Addendum No. 01

Subject: William H. Hunter ES – Classroom Modernization
SDP Contract Nos. B-055C, B-058C, of 2017/18

Location: WH Hunter ES
2400 N. Front St.
Philadelphia, Pennsylvania 19133

DRAWING NO.
14.1
SHEET OF

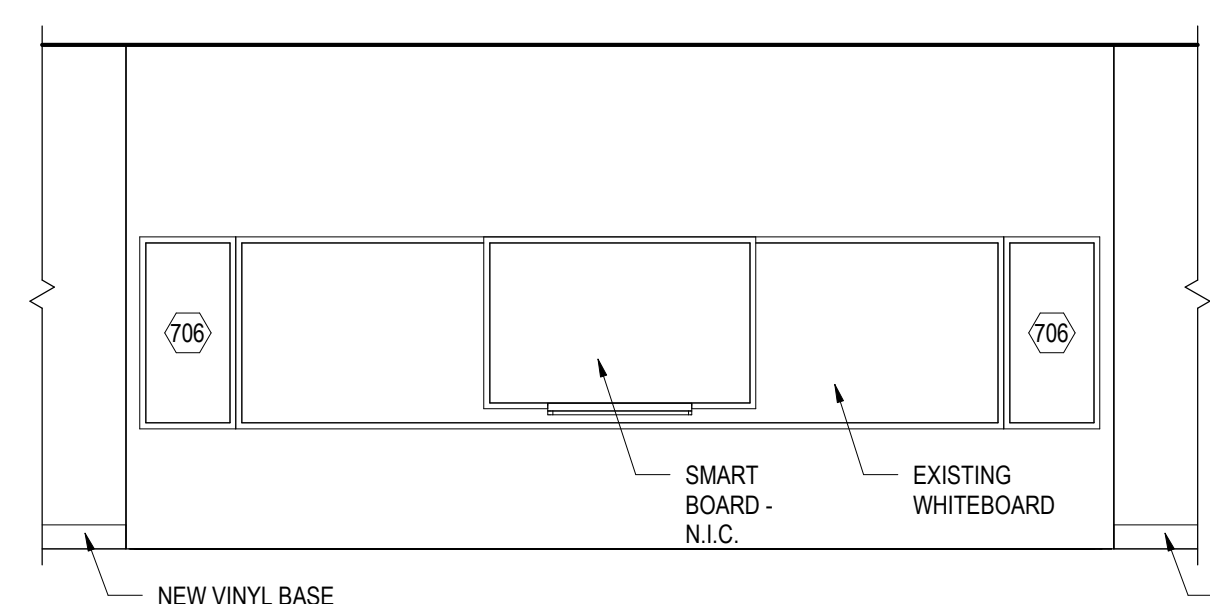
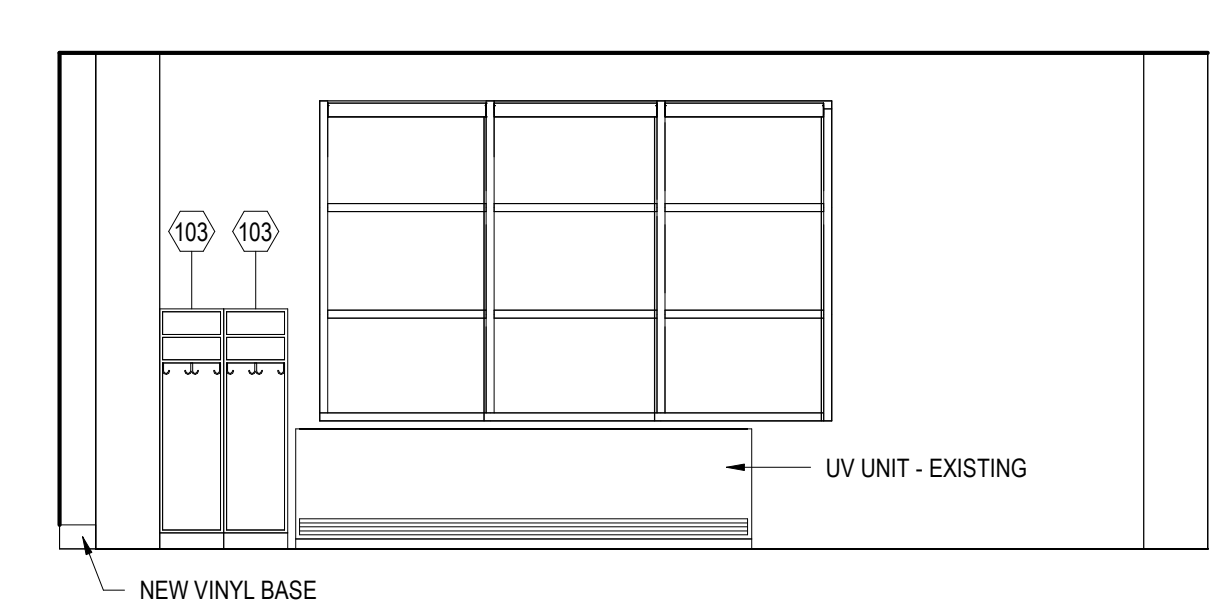
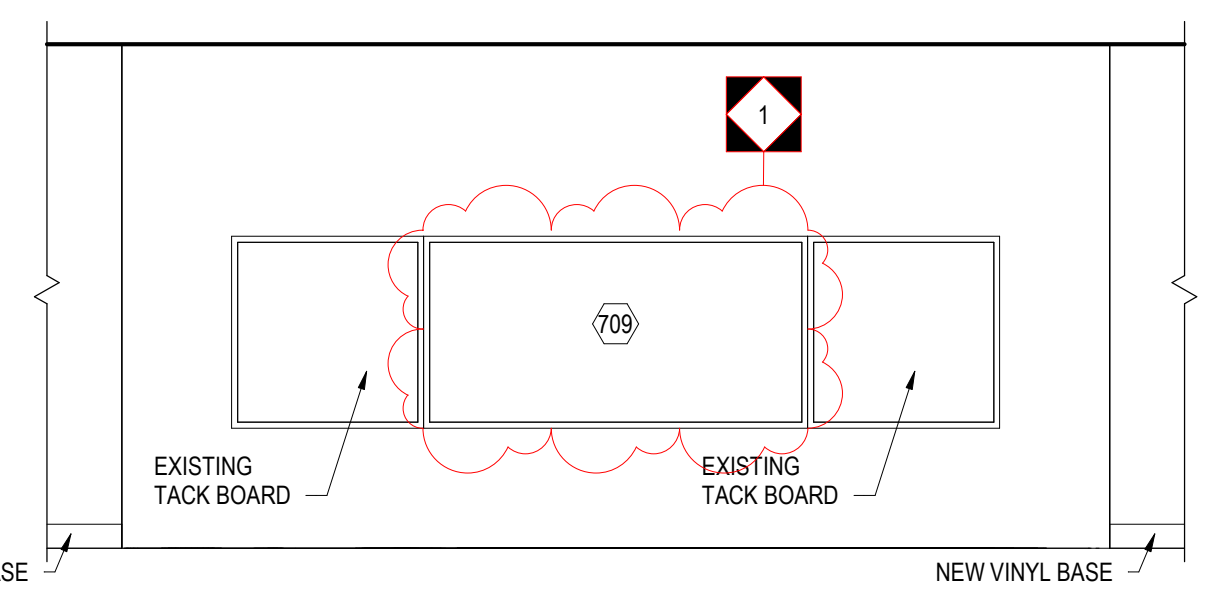
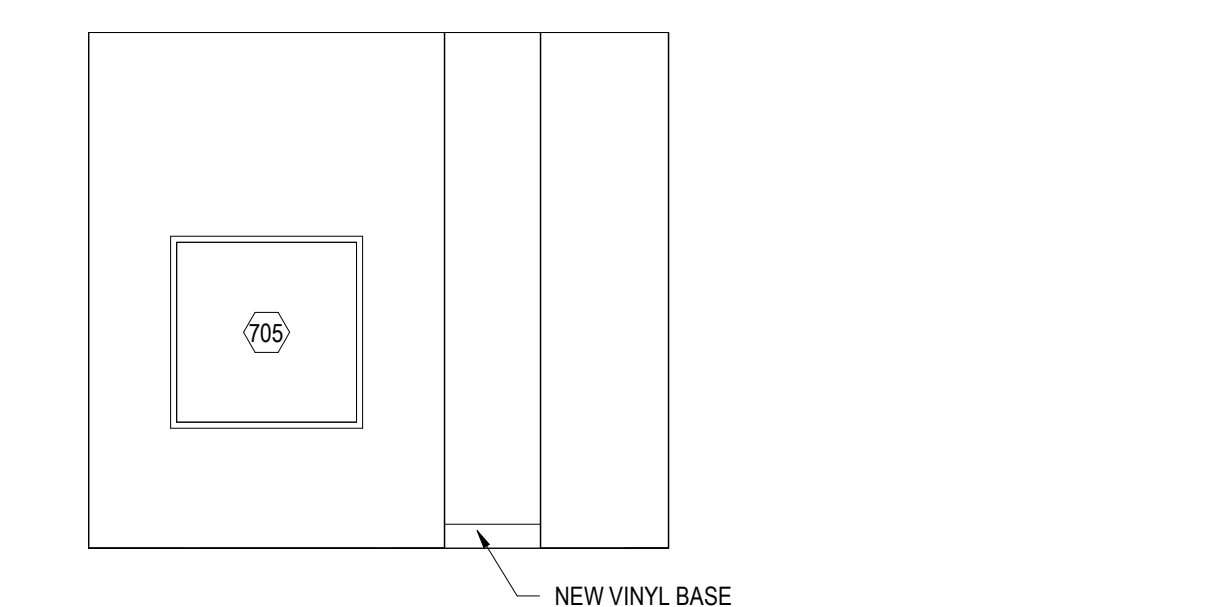
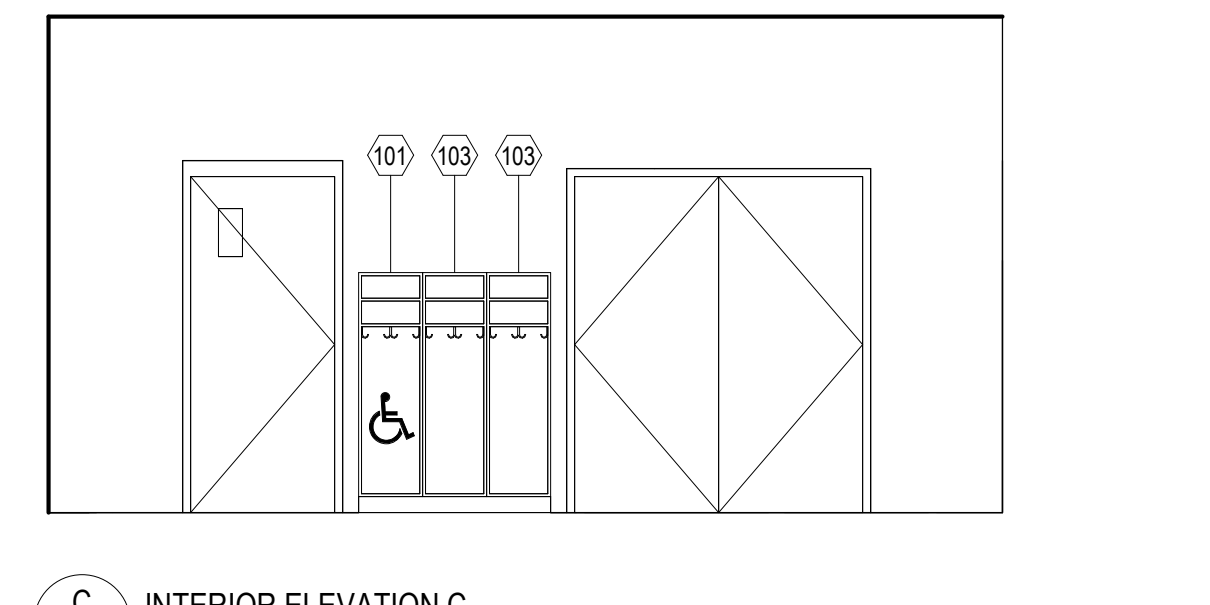
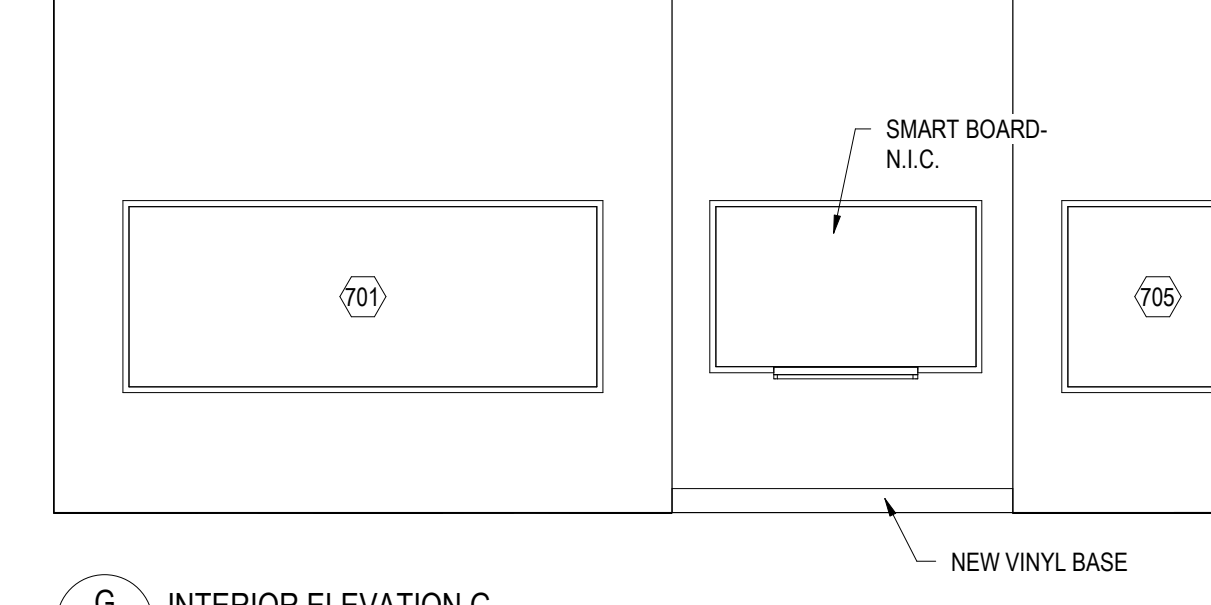
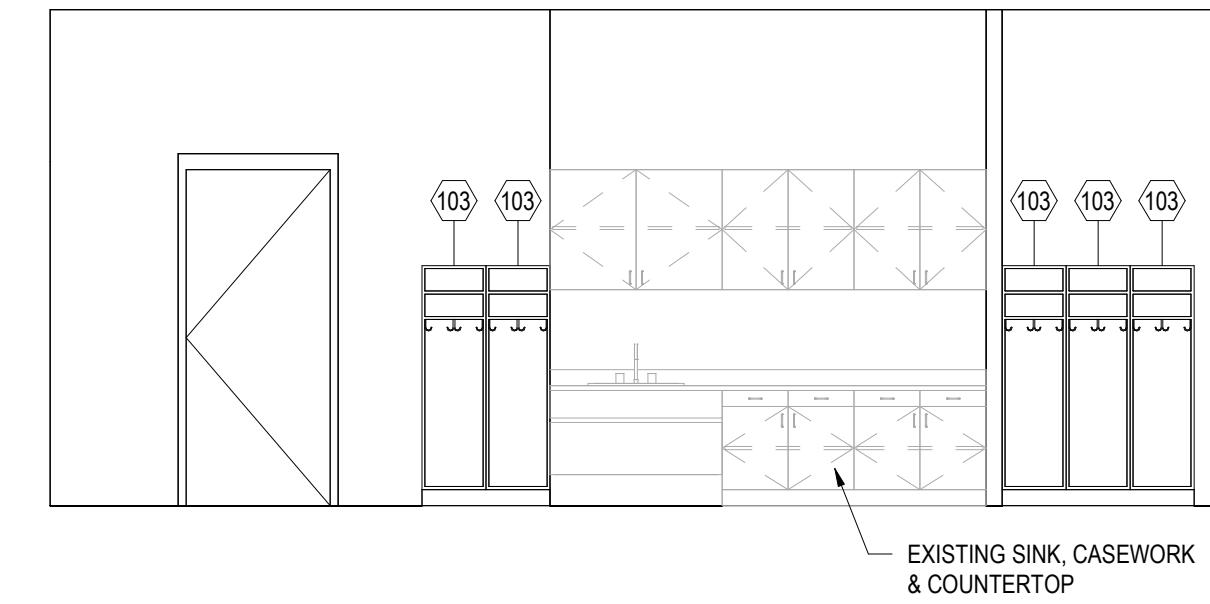
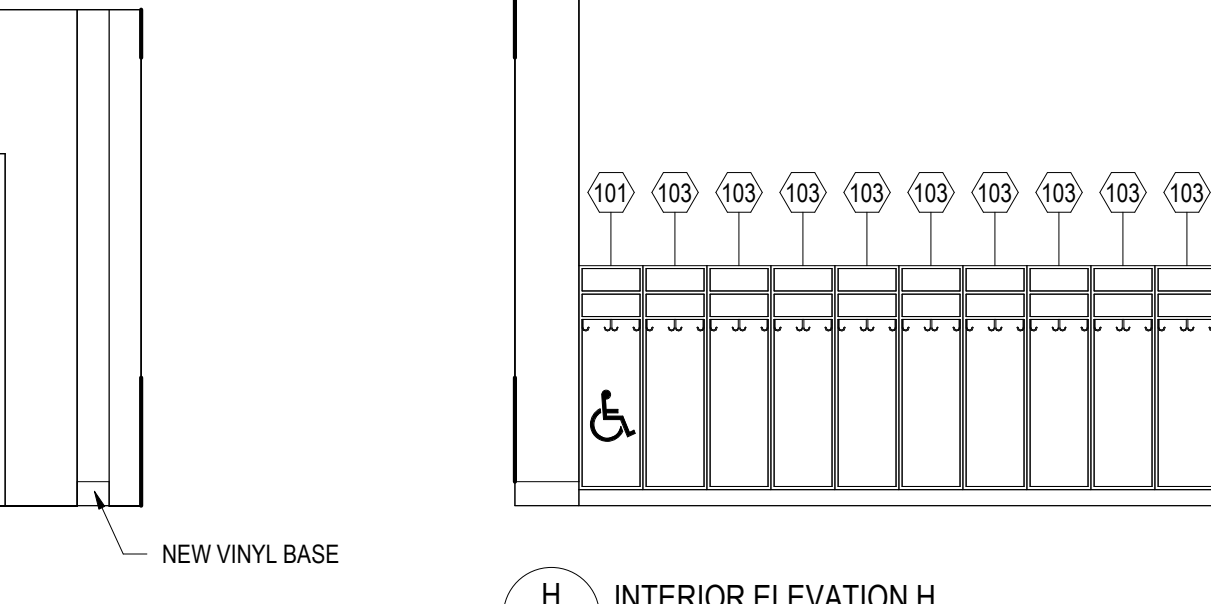
1. **REVISE** 702 marker board to 709 tack board.
2. **ADD** existing tack board.
